OWNER CHANGE ORDER

NO.: 007

TITLE: OCO #007 - PCI: # 28, #29, #31, #32, #34 & #35
PROJECT: Magnolia Science Academy
TO: Magnolia Educational and Research Foundation
250 E. 1st St., 1500
Los Angeles, CA

DATE: 05/15/2019
PROJECT NO.: 18049
CONTRACT: 18049

1 ROOF DEPRESS FRAMING DETAIL

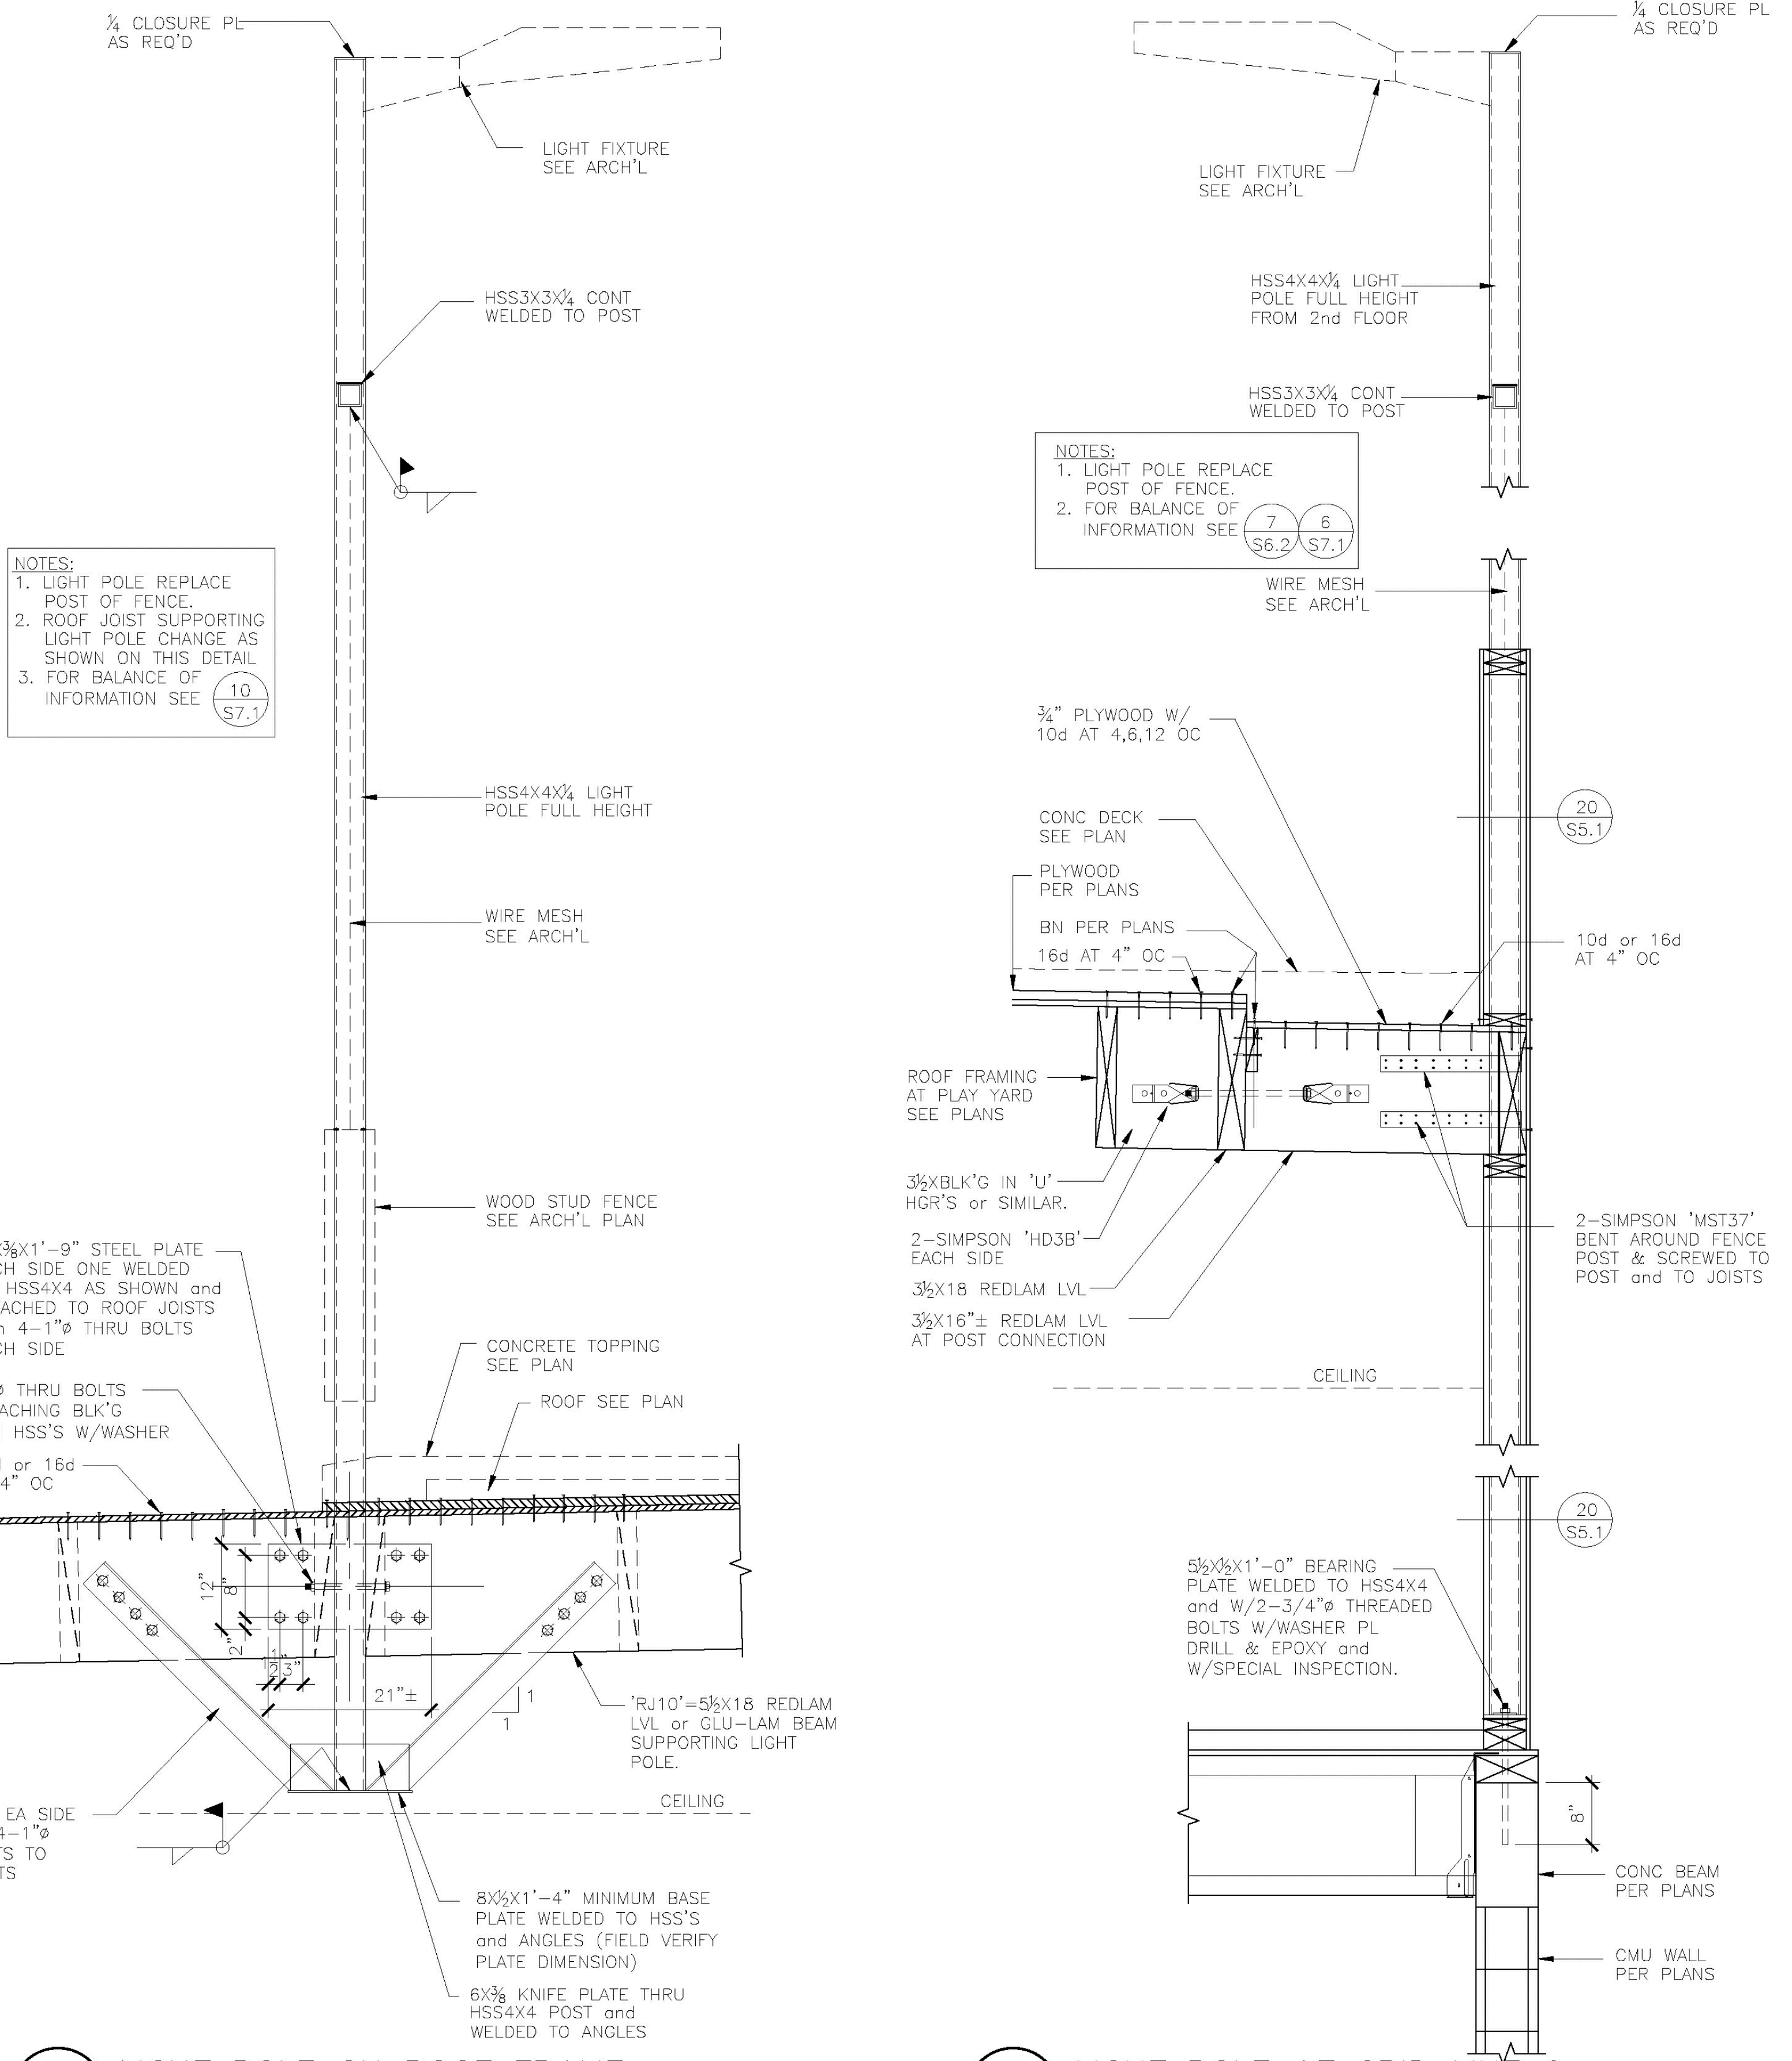
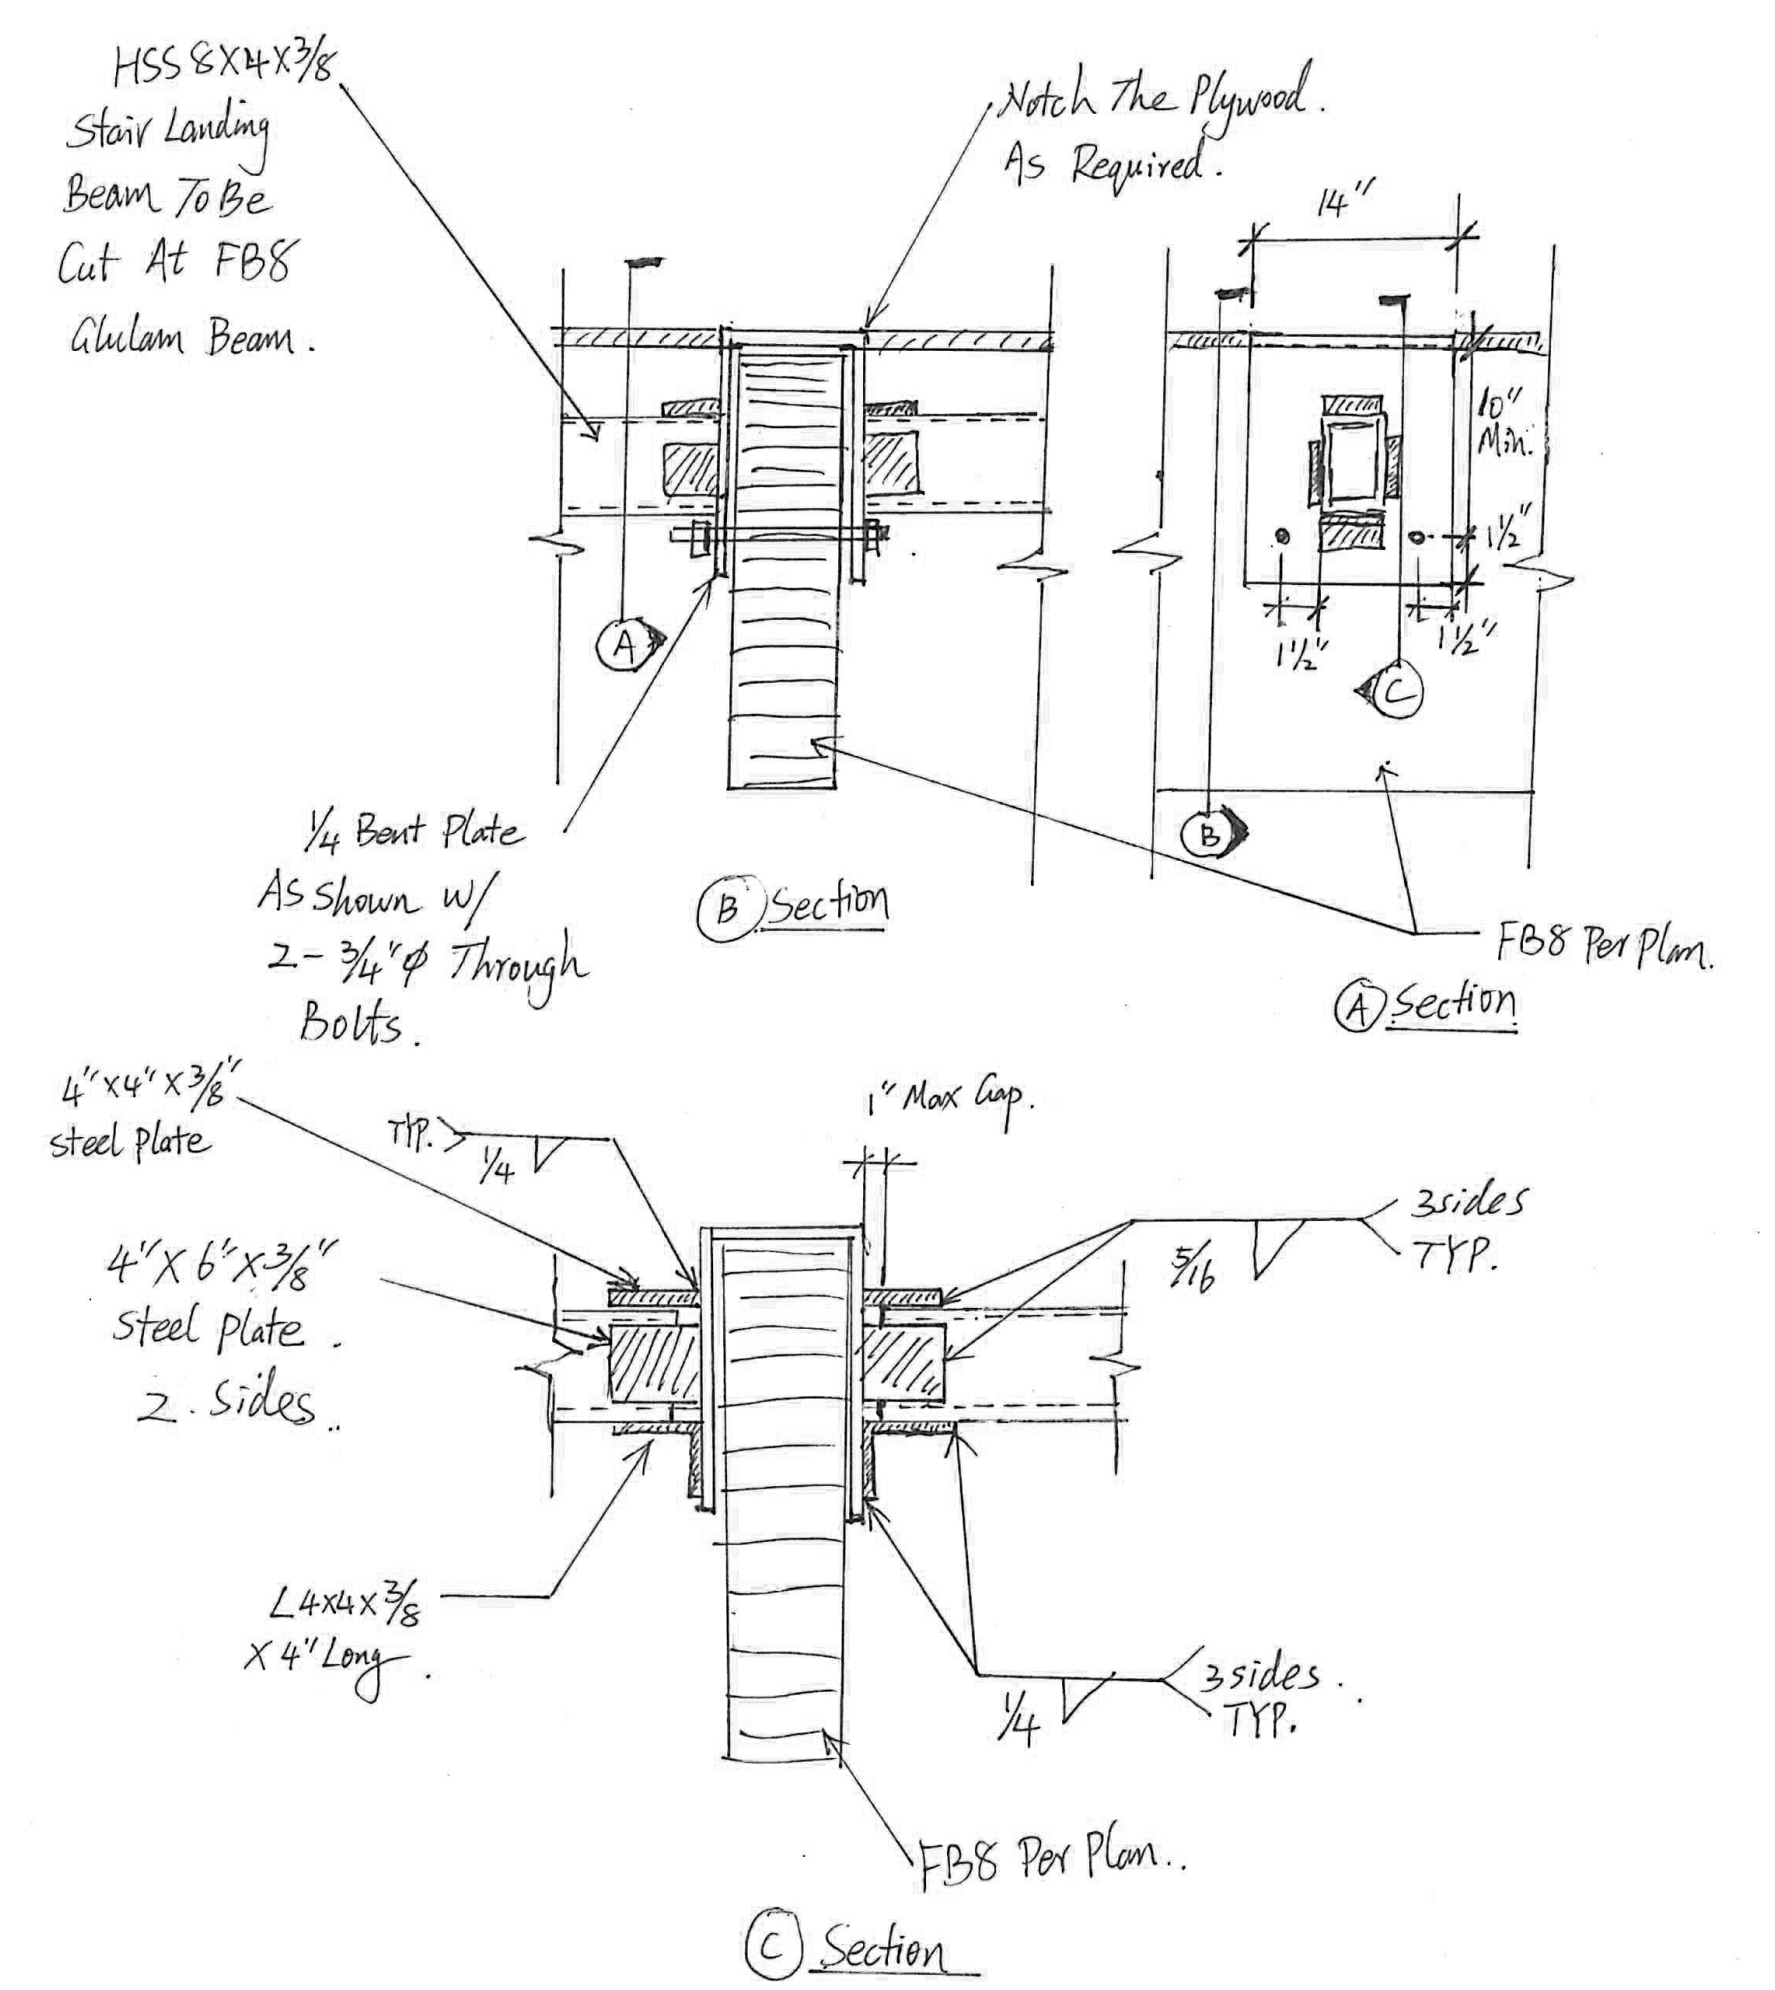
MSA Roof Depress
Along Grid 6.

Note: This detail is only for roof depress.
Please follow the approved structural drawing
for other parts of construction
